GEOLOGY AND SOILS REPORT APPROVAL LETTER

LOG # 131896-01
SOILS/GEOLOGY FILE - 2

**RESPONSE TO LADBS REVIEW COMMENTS
REVISED LIMITED GEOTECHNICAL EXPLORATION
3801 TO 3855 FLOWER DRIVE
AND 3822 TO 3830 SOUTH FIGUEROA STREET
CITY OF LOS ANGELES
CALIFORNIA**

**Subject: Response to LADBS Review Comments
Revised Limited Geotechnical Exploration
3801 to 3855 Flower Drive and 3822 to 3830 South Figueroa Street
City of Los Angeles, California**

Revised Figure 2a – Exploration Location Map

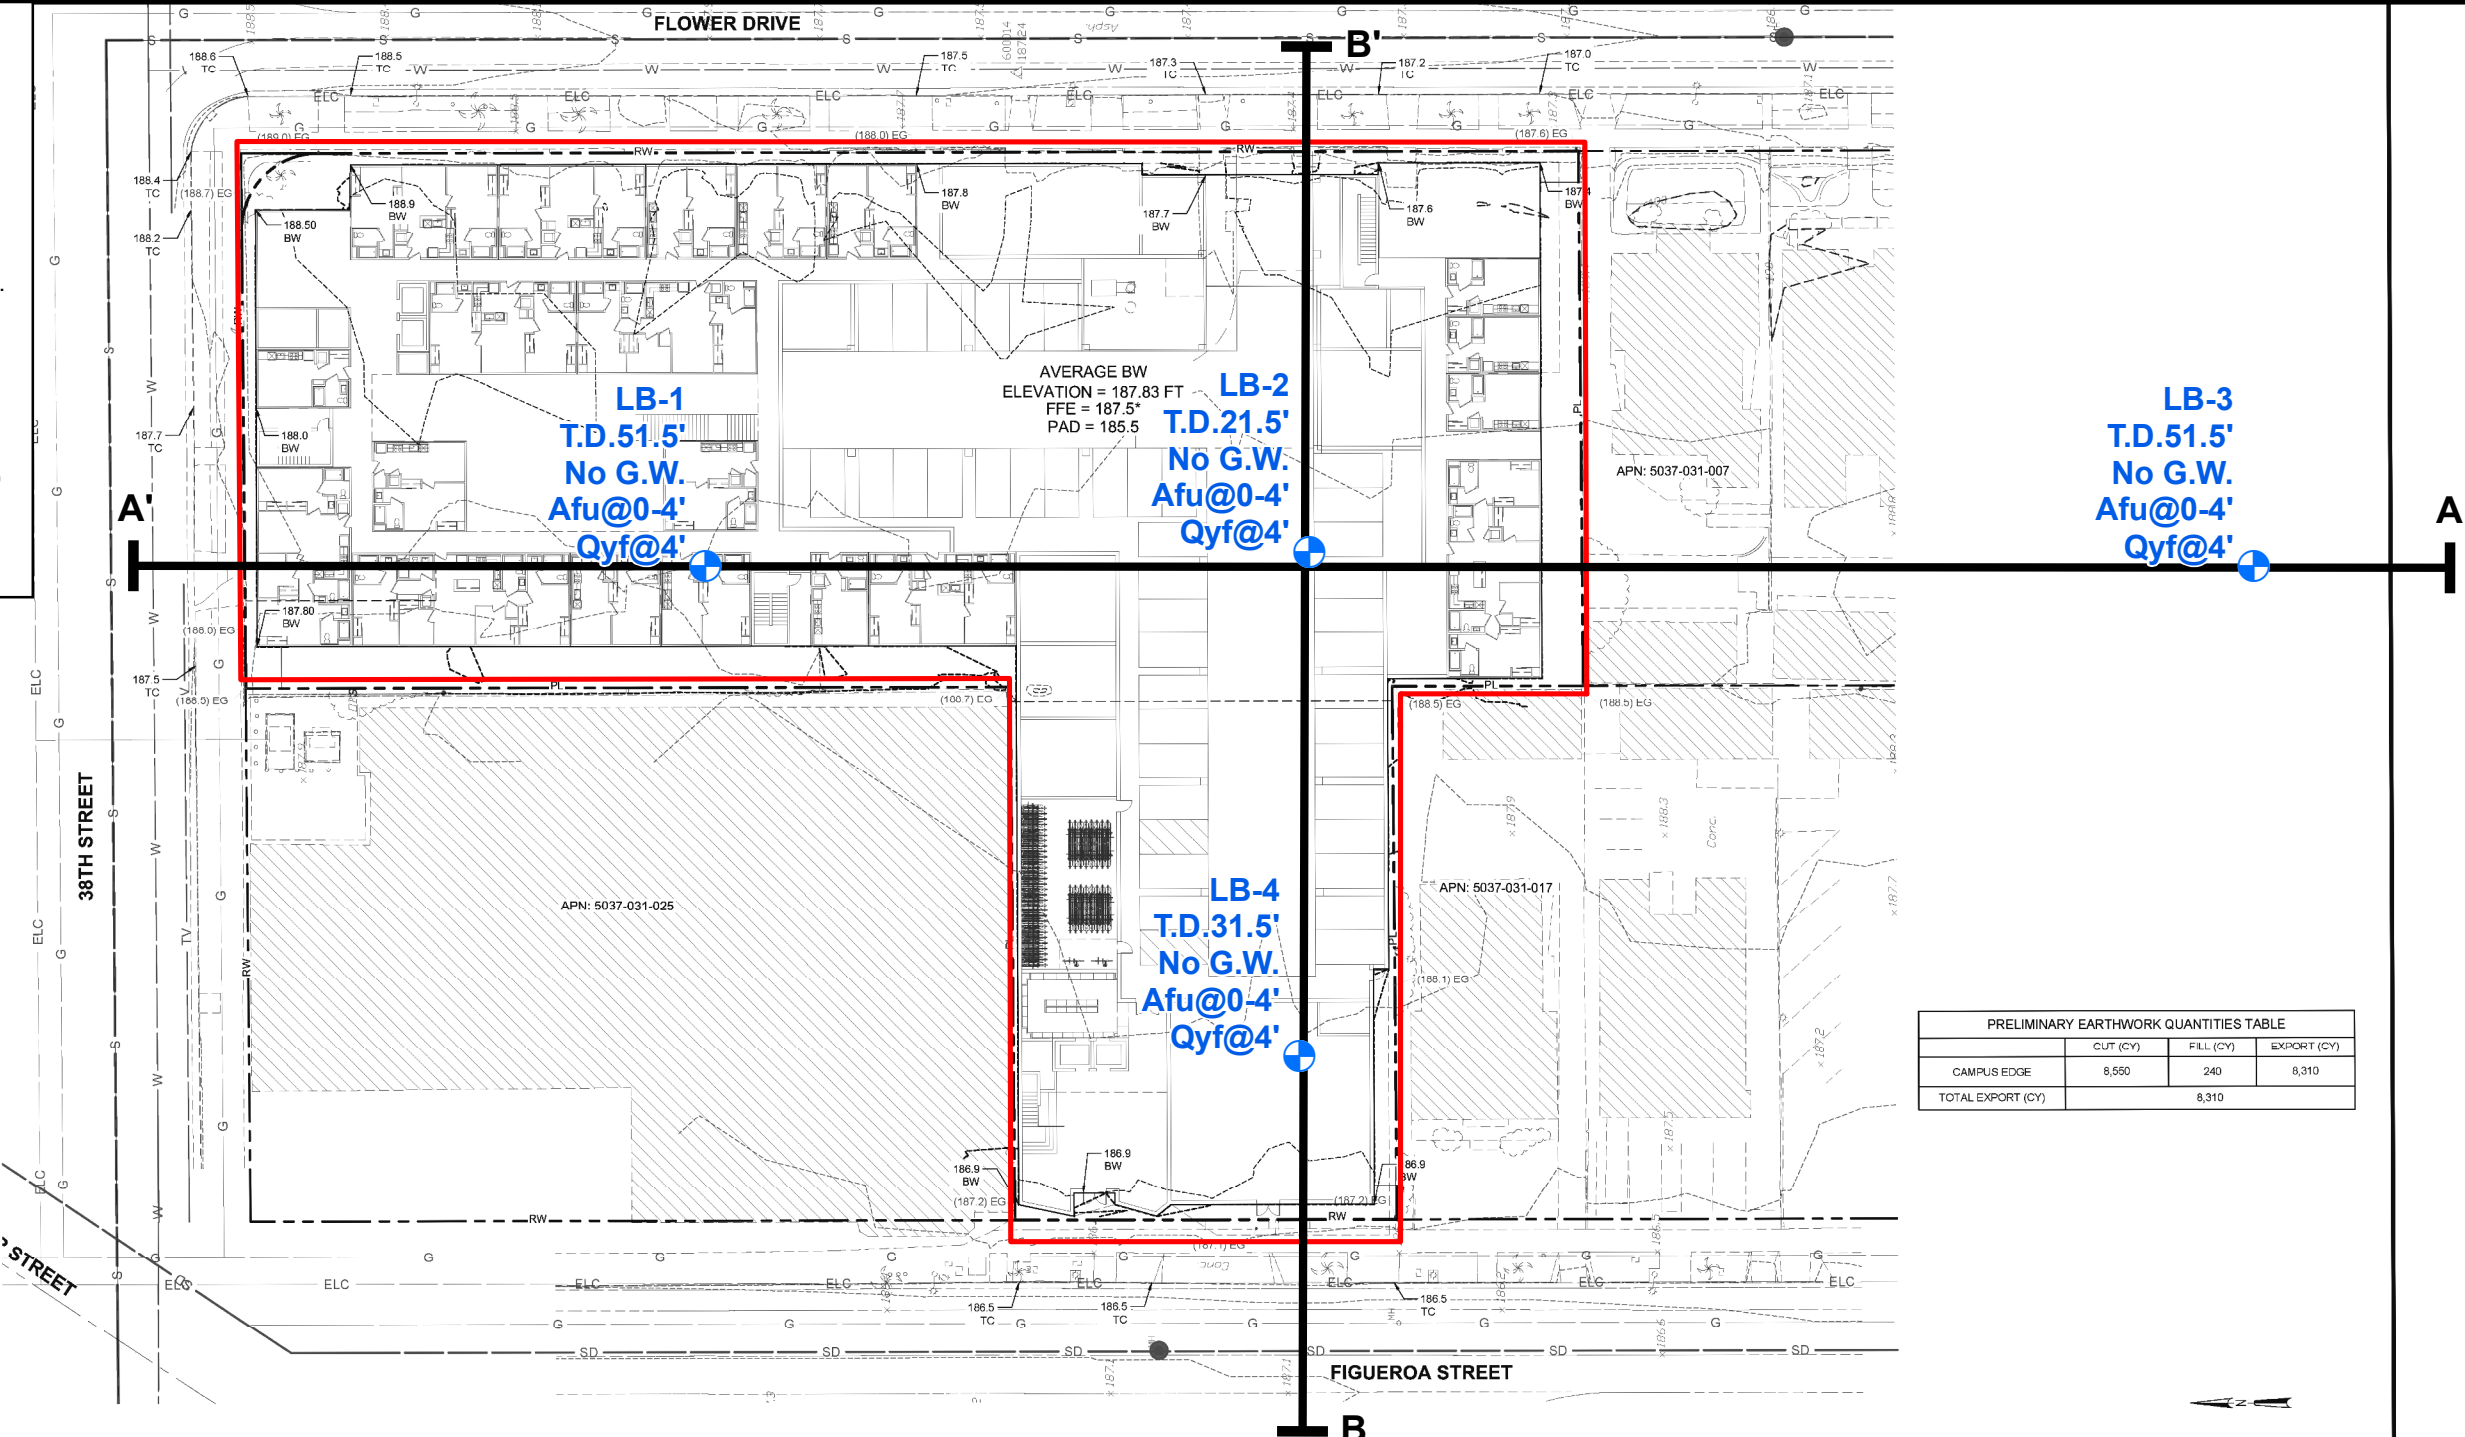
Provide a design-level geotechnical report including a geotechnical map showing the location of all proposed improvements, and recommendations to support the proposed improvement design.

The purpose of the limited geotechnical investigation was to generally characterize the subsurface conditions and geological hazards to support preparation/analysis of the Environmental Impact Report (EIR) and concept plan development. Design level investigations will be conducted in the future to support the project as it is developed. We have used Sheet 1 of 2 of the *Preliminary Rough Grading Plan*, prepared by David Evans and Associates, dated June 6, 2024, as the base map to present our boring locations and

cross section locations. Figure 2c, *Cross Sections AA and BB* present the general subsurface conditions interpreted from the boring data.
